Wiltshire Council Planning Consultation Response

URBAN DESIGN

Application No: PL/2025/09623

Proposal: Application for the Approval of Reserved Matters (Appearance, Landscaping, Layout and Scale) for the Erection of 60 Dwellings, Public Open Space, Landscaping and Associated Infrastructure following Outline Planning Permission PL/2023/06204.

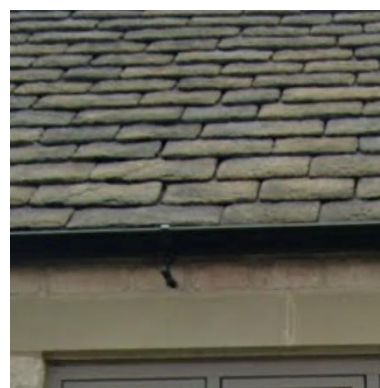
- 4) In regard to the following detail, each house elevation would not respect the characteristic intrinsic features of dwellings in the village and which has been carried through in the design of other modern housing development in the village:
- a) The omission of 'stone' window heads and additional masonry height between first floor openings and eaves. This is a characteristic feature of both stone faced and rendered facades in the village. ✗ 09.06.2026 Not addressed
- b) The omission of stone window heads and stone cills to side elevation openings and to rear elevation openings (door and windows). ✗ 09.06.2026 Not addressed other than where side elevation directly faces the street. Rear elevations would be visible above rear garden high boundaries in views along the streets , and in conjunction with point 4a above.

- c) The gable ladders universally applied to side elevation main gable ends and mid gables on front elevations whereas a mortared edge is an intrinsic characteristic. Eg Manor Farm Drive, Seagry Road recent housing. **X 09.06.2026 Not addressed.**

X 09.06.2026 Not addressed - See precedent photo examples in the village below.

Characteristic of Sutton Benger - Britains Close and Arms Gardens -first floor stone window heads (not fascia eaves directly down over window opening) and stone heads and cills to rear elevation and side elevation openings also. Mortar gable ends, traditional sprocket eaves, not universal box fascia/soffit to eaves and gable ends. Stone slates (Arms Gardens example) , Reconstituted slate (texture face/ riven edge) not grey concrete tile, traditional clay pantile, not plain tile or modern Double Roman pattern.
